CALIFORNIA REGIONAL WATER QUALITY CONTROL BOARD—
CENTRAL VALLEY REGIONSAN JOAQUIN WATERSHED BRANCH OFFICE:
3374 EAST SHIELDS AVENUE, ROOM 18
FRESNO, CALIFORNIA 93726
PHONE: (209) 445-5116SFUND RECORDS CTR
2360371

WASTE DISPOSAL ACTIVITIES - FRUITVALE OIL FIELD, KERN COUNTY

TO: F. Scott Nevins *fsn* 25 May 1983
FROM: C. Scott Smith
SUBJECT: STAFF REPORT ON GETTY REFINING AND MARKETING COMPANY - FRUITVALE
OIL FIELD, KERN COUNTY

SITE STUDY AREA WITHIN THE GRMC REFINERY
BAKERSFIELD, CALIF.

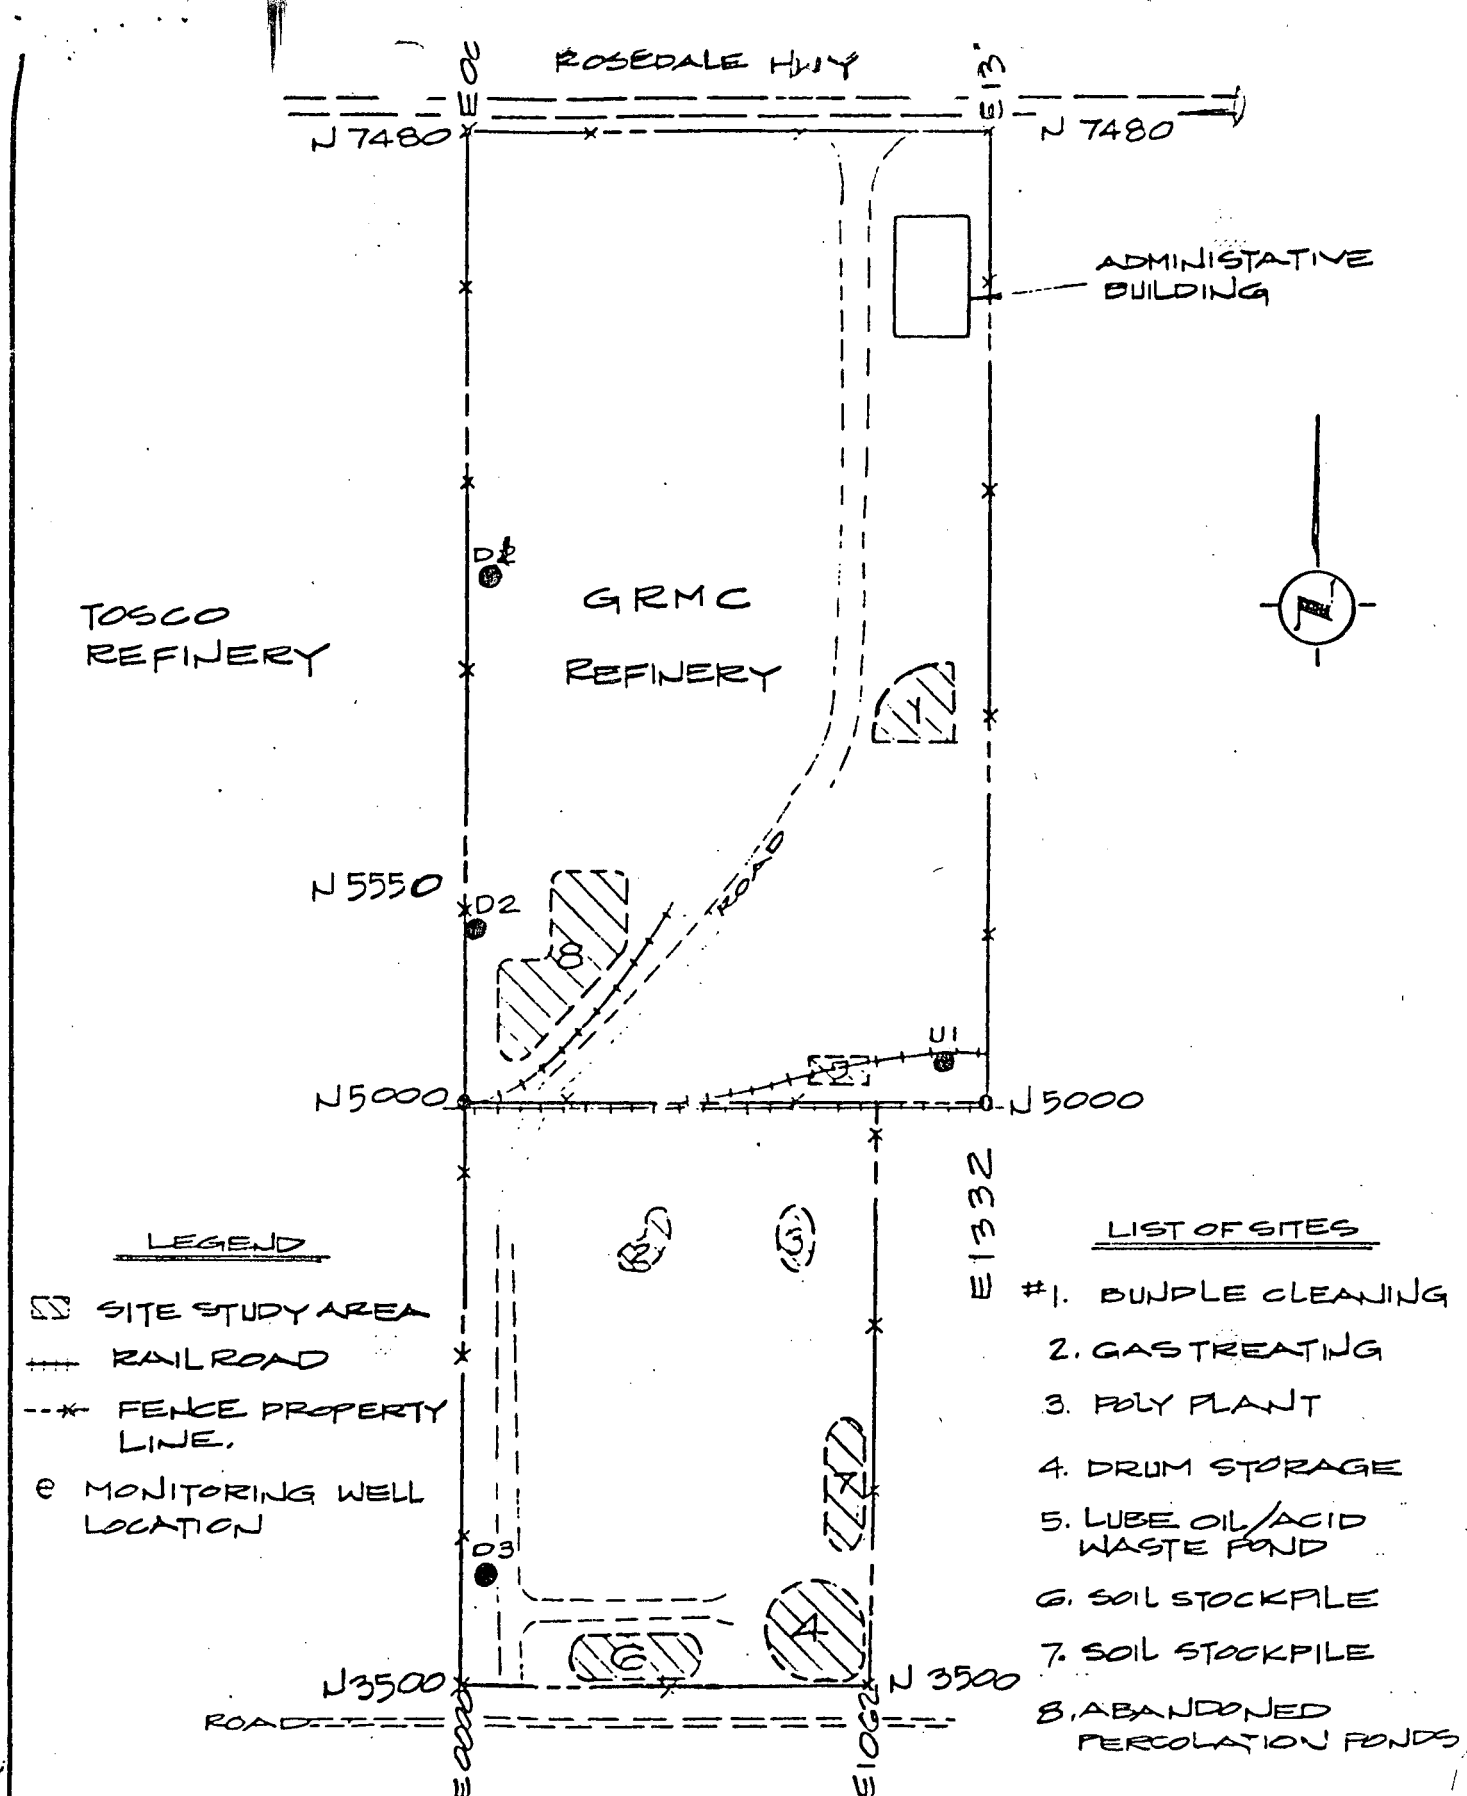
In March 1981, GRMC was issued an Interim Status Document (ISD) by the then Hazardous Material Management Section of the Department of Health Services requiring the implementation of a quarterly ground water monitoring program to determine the facility's impact on unconfined ground water. In accordance with the ISD, three wells designated as downgradient ground water monitoring wells (D1, D2, and D3 on Figure 1), and one monitoring well designated as up-gradient (U1) were installed.

The ground water quality monitoring results submitted to date preliminarily indicates that ground water quality degradation has occurred as a result of waste disposal practices. Phenols, arsenic, chromium, and lead, all of which have been found in ground water in excessive concentrations at the facility, are among the contaminants commonly associated with refinery wastes. Therefore, GRMC now needs to expand their monitoring program to determine the vertical and lateral extent of ground water degradation.

While available ground water level data indicates that Well No. U1 is presently upgradient of Well Nos. D1, D2, and D3, it is not clear that Well No. U1 is upgradient of all past disposal activities. The high contaminant levels exhibited by Well No U1 over D1, D2 and D3 suggest a source of contamination local to U1. GRMC should, therefore, investigate appropriateness of the local of U1. This may require the sampling of ground water upgradient of U1 at some location clearly outside the influence of past disposal activities for comparison purposes.

In February 1983, GRMC submitted the results of a soils testing program to determine the levels of contaminants at eight specific sites at the refinery where wastes have been previously disposed. The locations of the sites and their prescribed uses are indicated in Figure 1. The study was preliminary in nature and was not intended to define the full range of contaminants and their distribution in the soils.

On 26 April 1983, you and I met with Ms. Sue Luft and Mr. Gordon Turl of GRMC to tour the facility and visit each of the eight disposal sites. The GRMC representatives had specific questions regarding (1) cleanup of the bundle cleaning area and percolation ponds (Sites 2 and 8 respectively) so that new facilities could be constructed at these locations, and (2) the use of stock-piled soils (Sites 6 and 7) for spill containment berms.
